PSC Box Beam and PSC Cored Slab Beam Bridges Common Item and Quantity Errors

Example 1 - PSC Box Beam Bridge

BRIDGE SERIAL NO. 145-0052-0
 BRIDGE I.D. NO. 145-01427F-001.78E
 PROJECT P.J. NO. 0015315

BRIDGE NO. 1		GEORGIA	
DEPARTMENT OF TRANSPORTATION			
ENGINEERING DIVISION-OFFICE OF BRIDGES AND STRUCTURES			
PLAN AND ELEVATION			
CR 29 (OLD WEST POINT RD)			
OVER CHATTAHOOCHEE RIVER TRIBUTARY			
HARRIS COUNTY			0015315
SCALE: 1" = 10'-0" (UNLESS OTHERWISE NOTED)		JULY 2017	
DRAWING NO. 35-0001	DESIGNED <u>KNT</u>	CHECKED <u>VMW</u>	REVIEWED <u>DLC/SKG</u>
BRIDGE SHEET 1 OF 13	DRAWN <u>KNT</u>	DESIGN GROUP <u>EJC</u>	APPROVED <u>WMD</u>

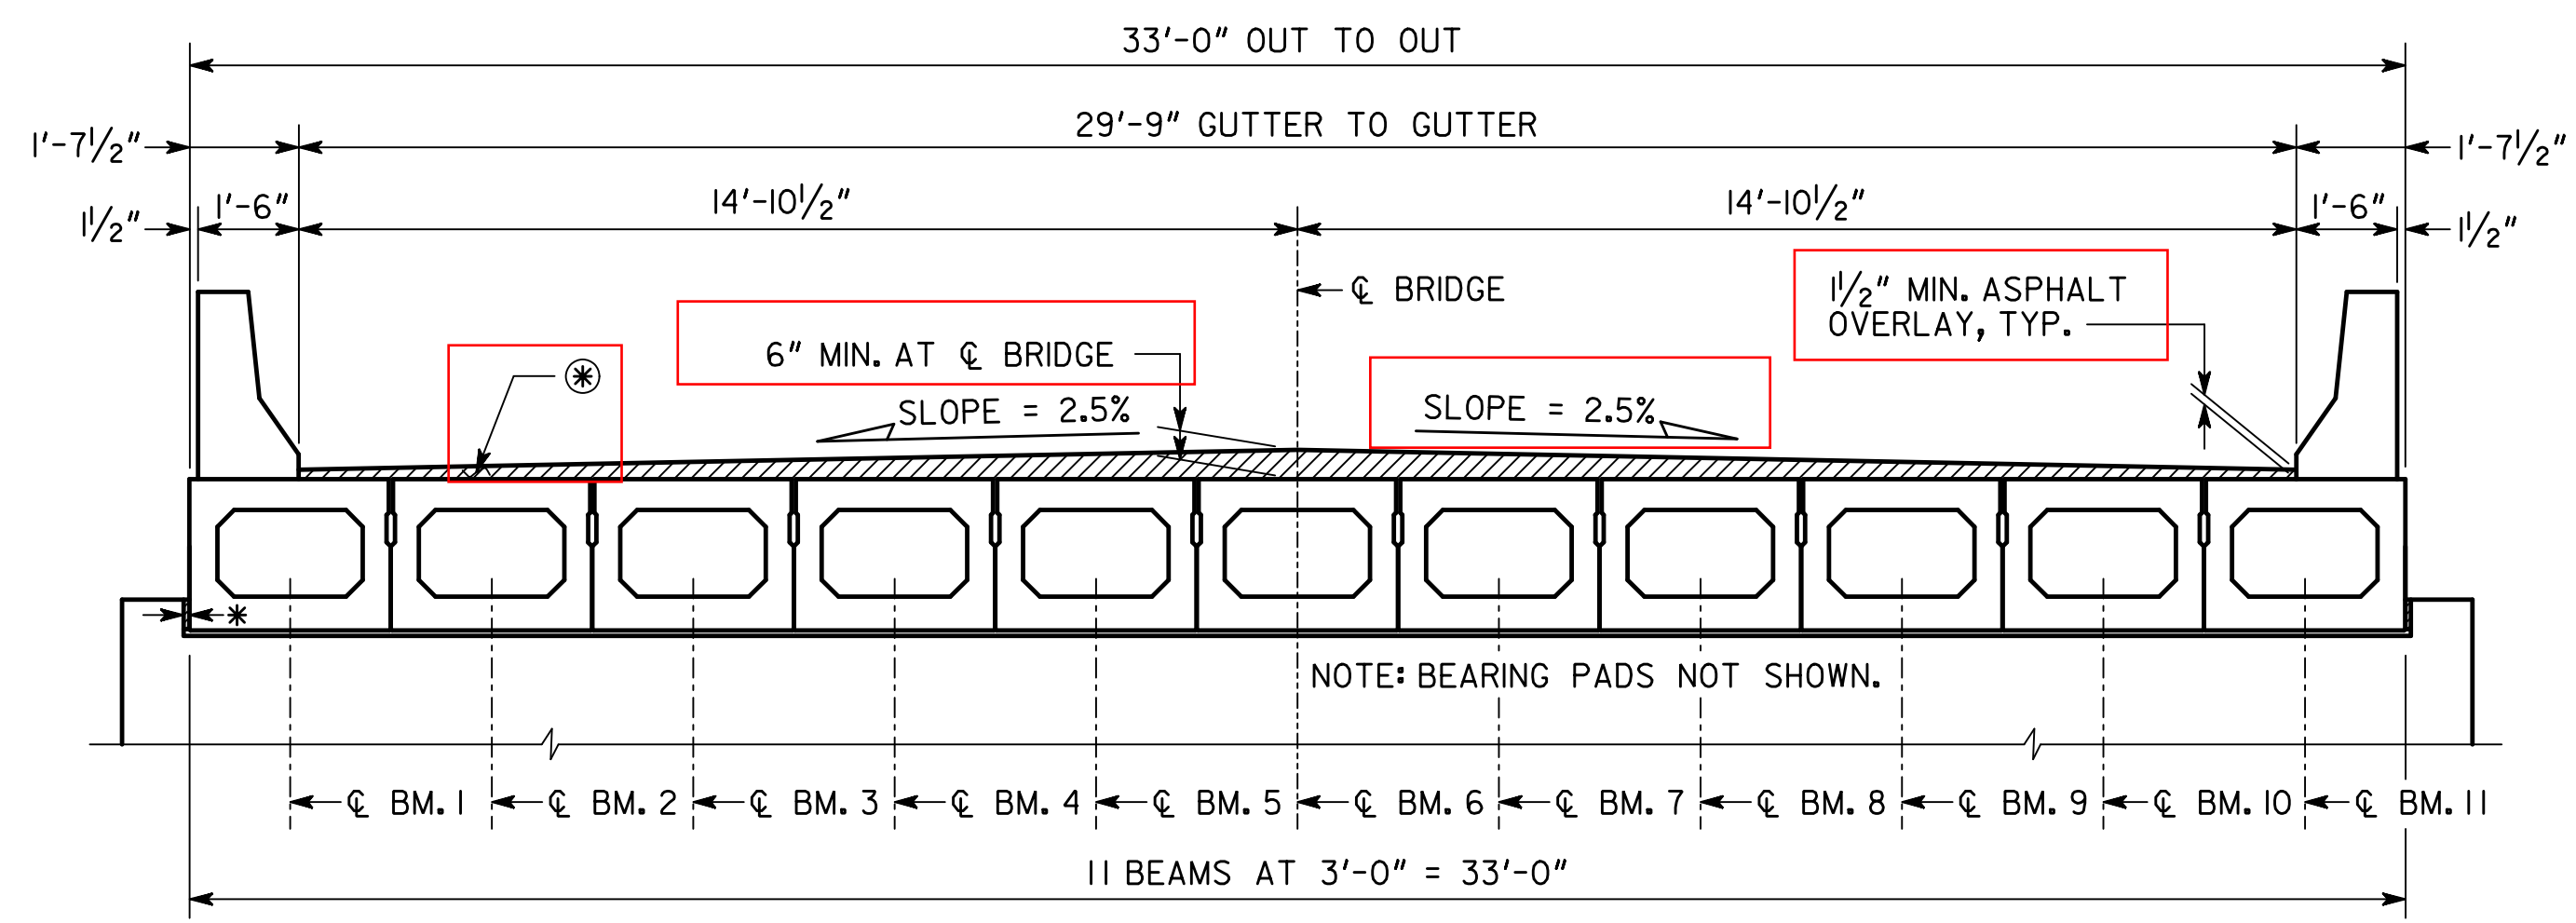
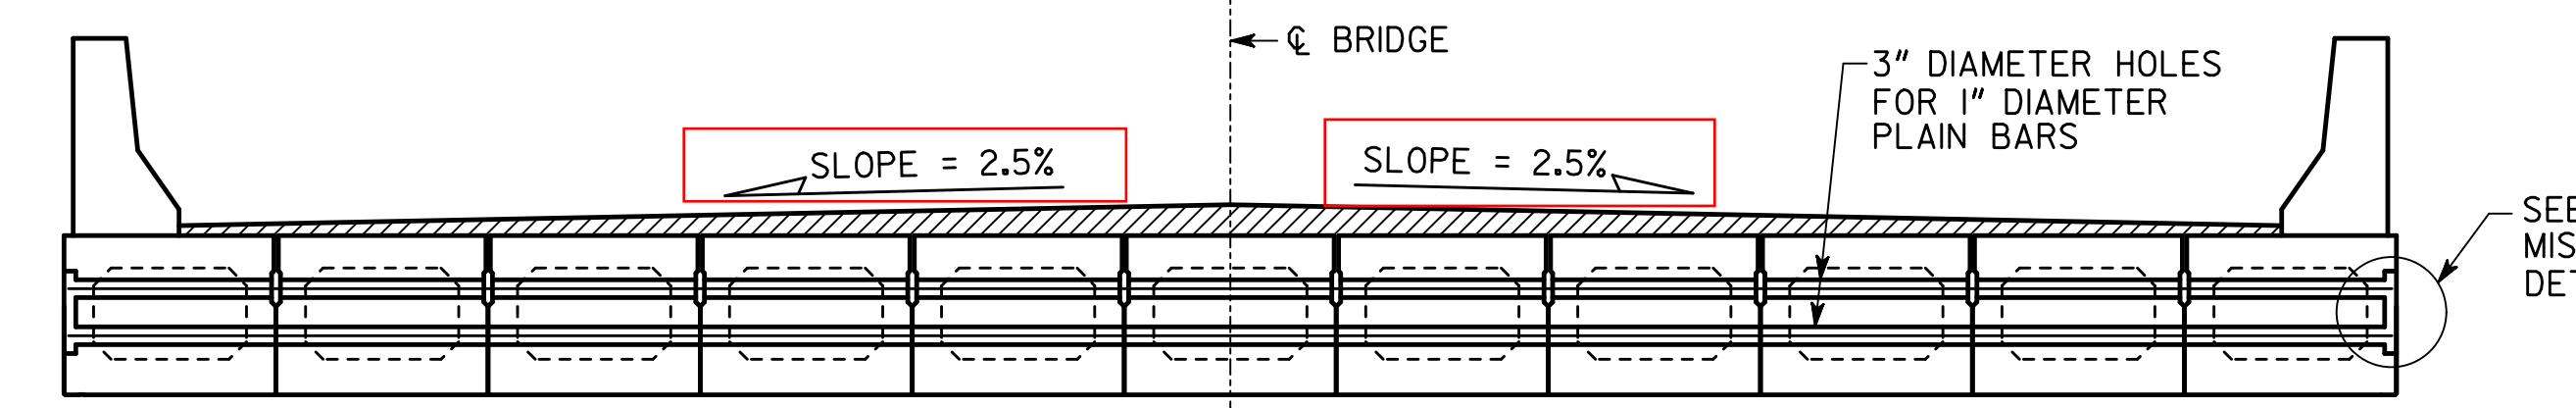
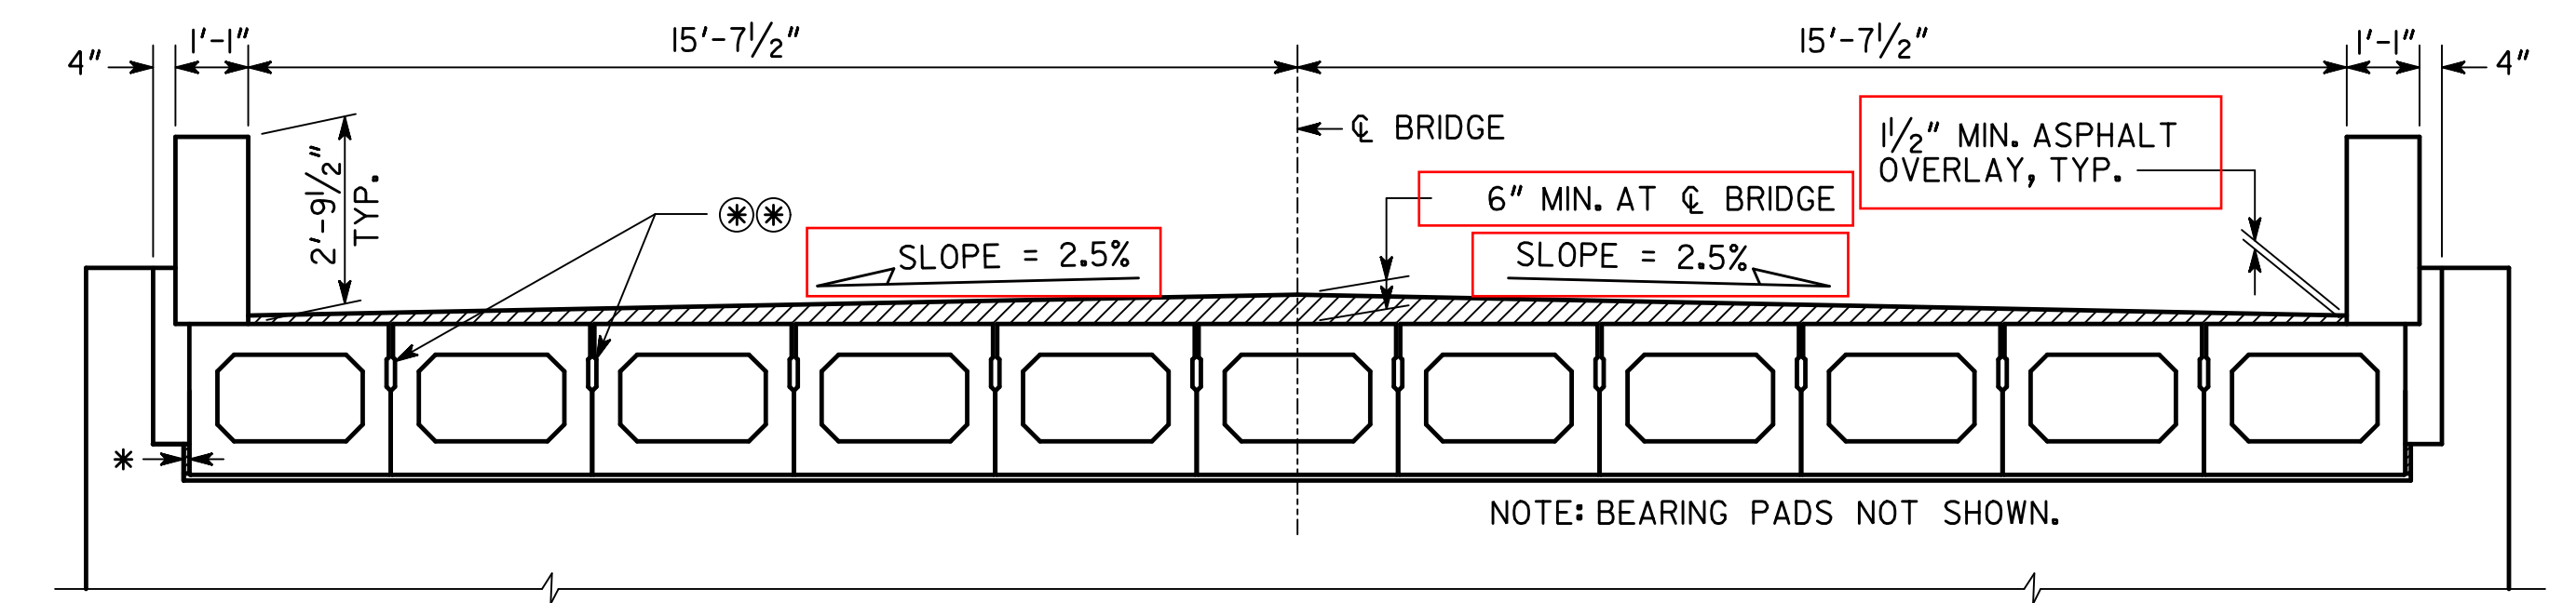
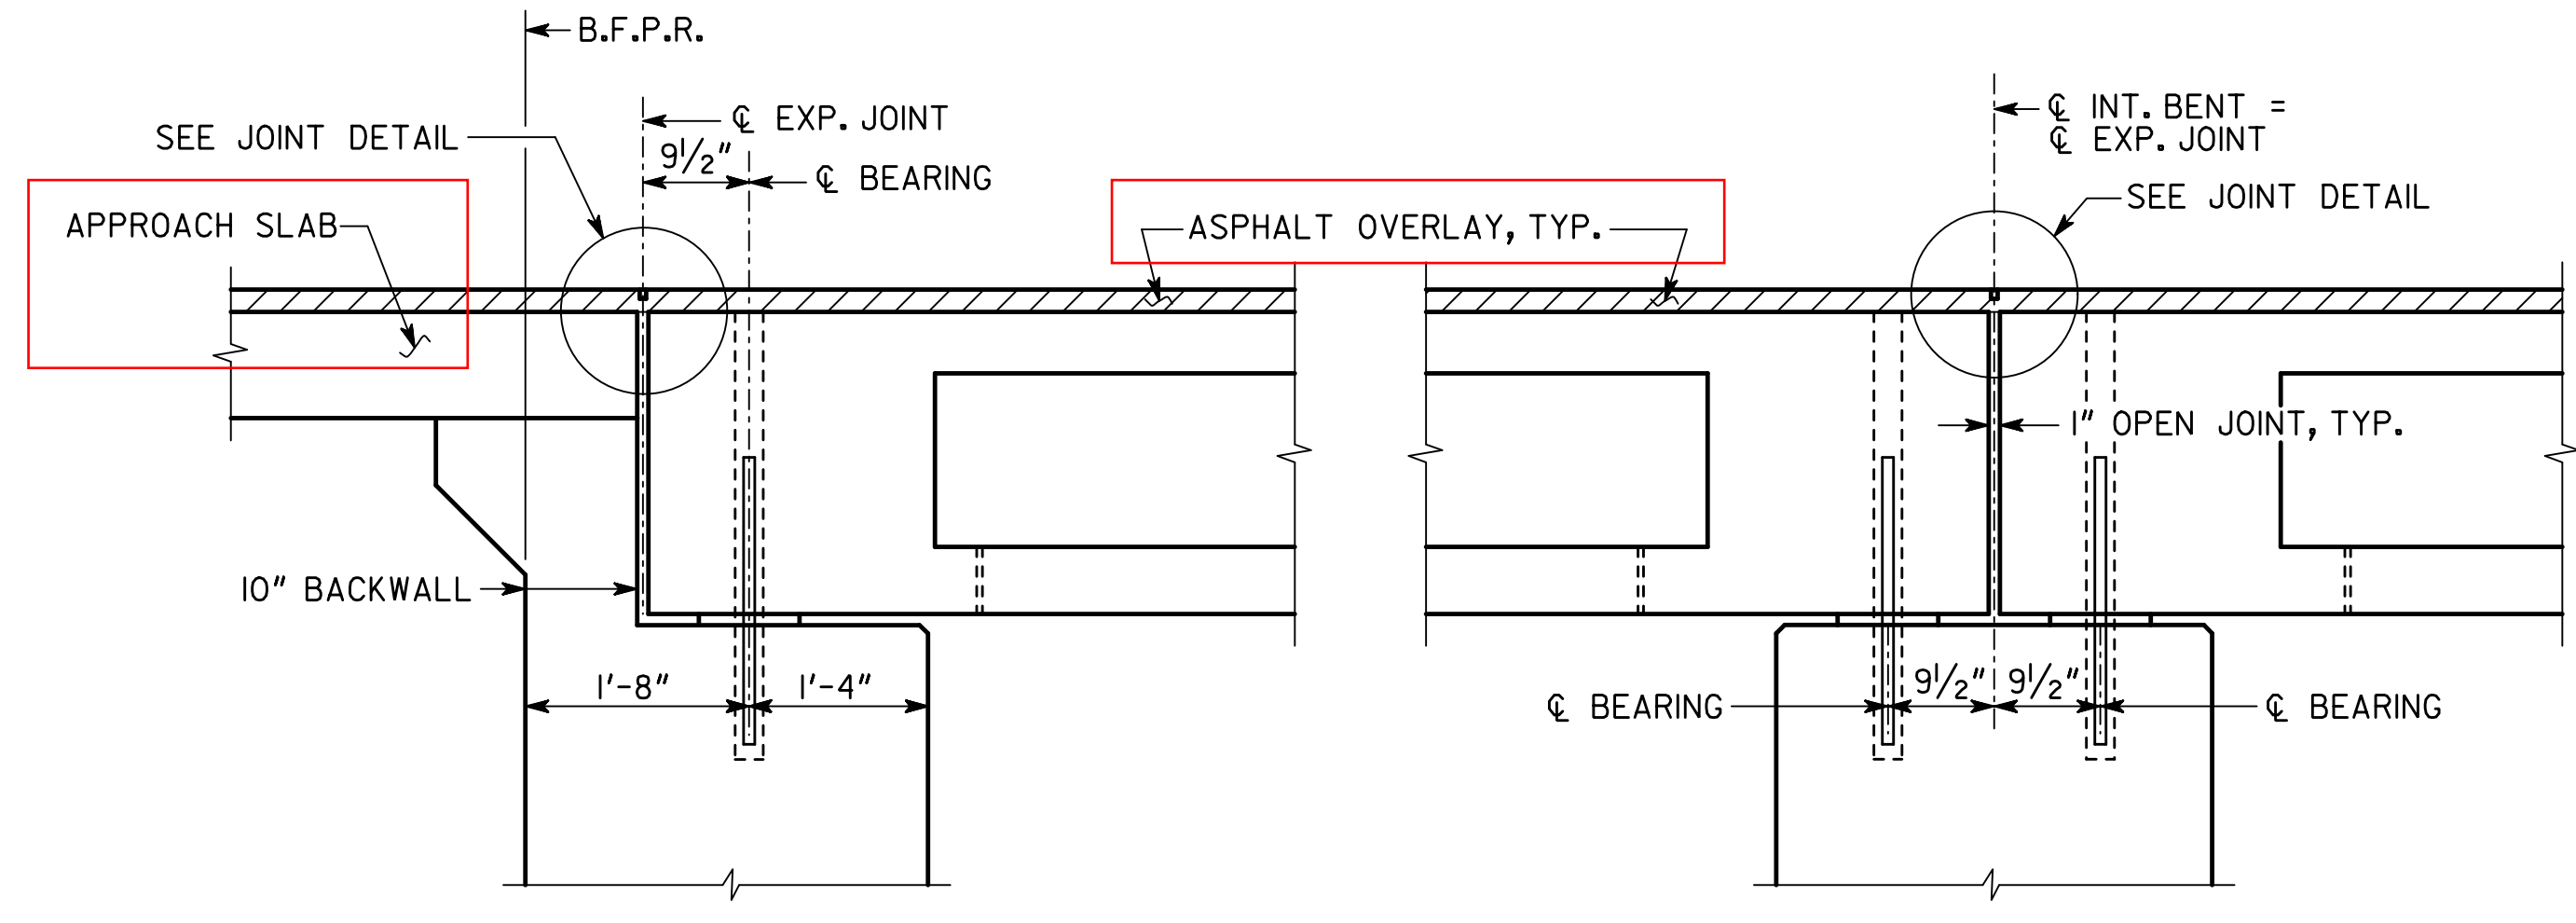
Review all the items outlined in red.
 Notice that the cross slope for this tangent alignment bridge is 2.5%.
 Since the bridge deck is leveled and overlaid the approach slabs are also leveled and overlaid. See the End Bent Joint Detail.
 Roadway cross sections will have to account for cross slope transition to meet the bridge cross slope.
 The Recycled Asphaltic Concrete Surface Course used on the bridge and approach slabs is the same as the roadway and should have the same spread rate. Typically this is either 135 lb/sy for 9.5 mm SP which is 1.25-inch thick or 165 lb/sy for 12.5 mm SP which is 1.5-inch thick. Leveling is used from the top surface of the Box Beams to the bottom of the surface course with the leveling creating the cross slope.
 This project uses 9.5 mm SP thus the leveling thickness using the minimum overlay thicknesses specified this 0.25-inch thick at the gutter line and 4.75-inch thick at the CL.
